Olympics Enabling Works

Construction Zone 3a Change Notice Report Discovery of Radioactive Substances

May 2010

Figure 2 A Section through the proposed Waste Disposal Cell

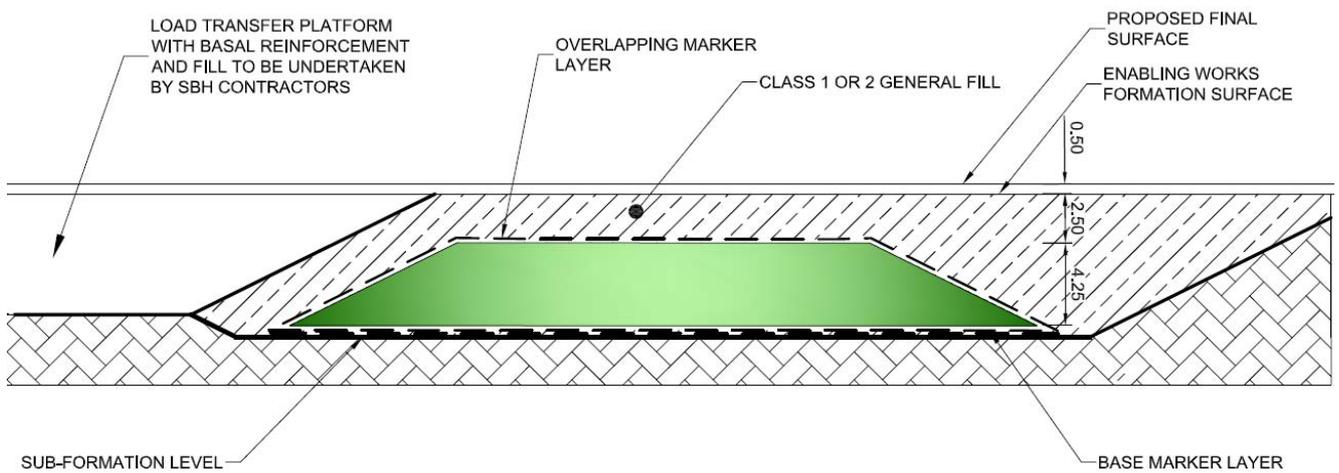
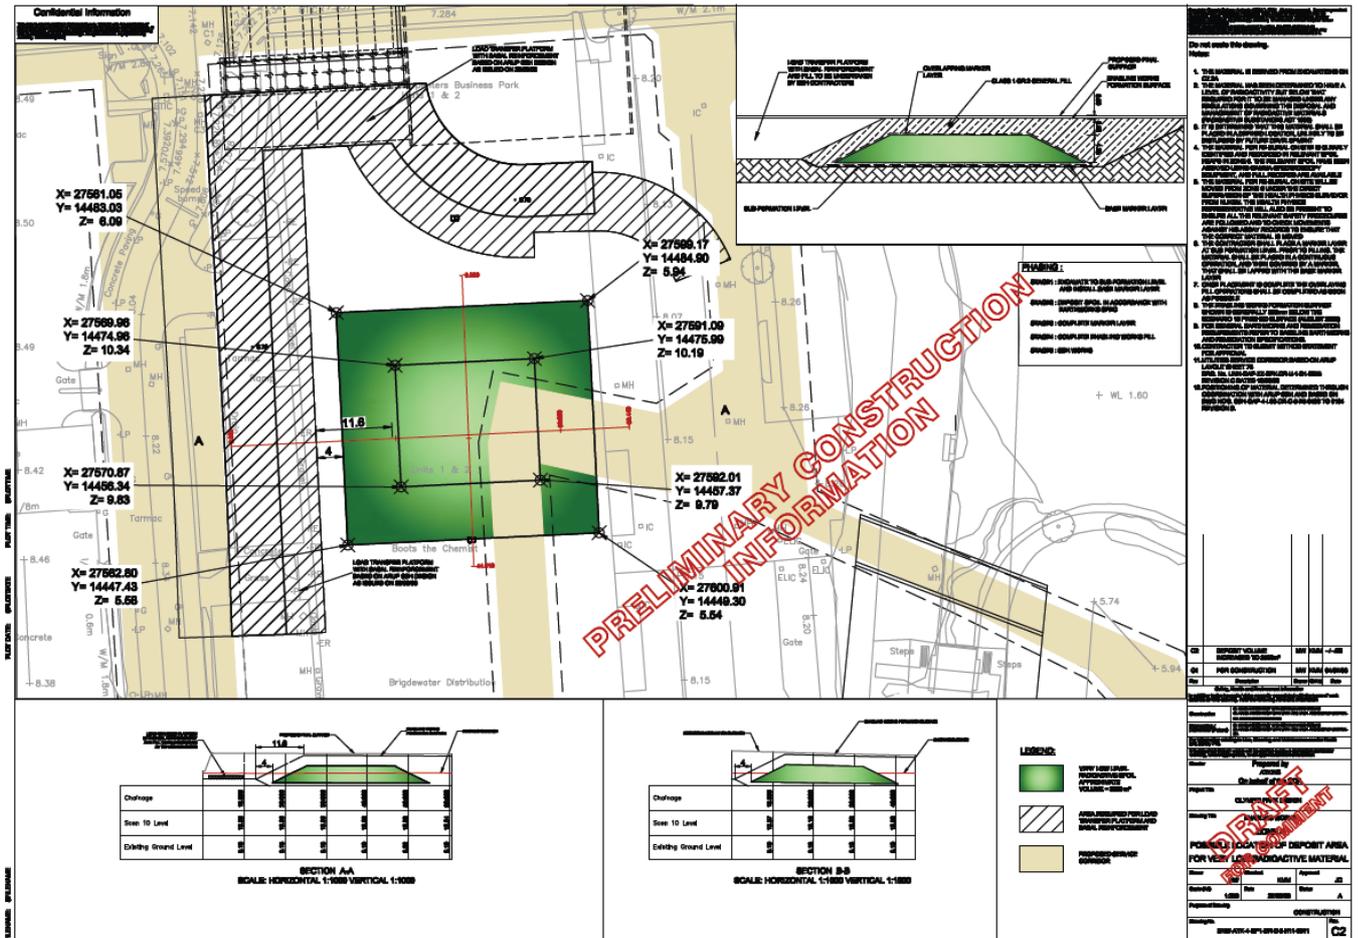
The disposal cell is in the form of a truncated pyramid. It is covered on its sides and capped with a layer of clean general fill. Over the top surface will be a road. This will form an additional shielding layer of 0.5 m thickness. Its bitumen top surface will also restrict water infiltration. The contaminated fill zone will be covered, top and bottom, by an overlapping marker. This will likely be a polymer sheet wrap. In the short term this will also act as a further barrier to water infiltration into the waste.
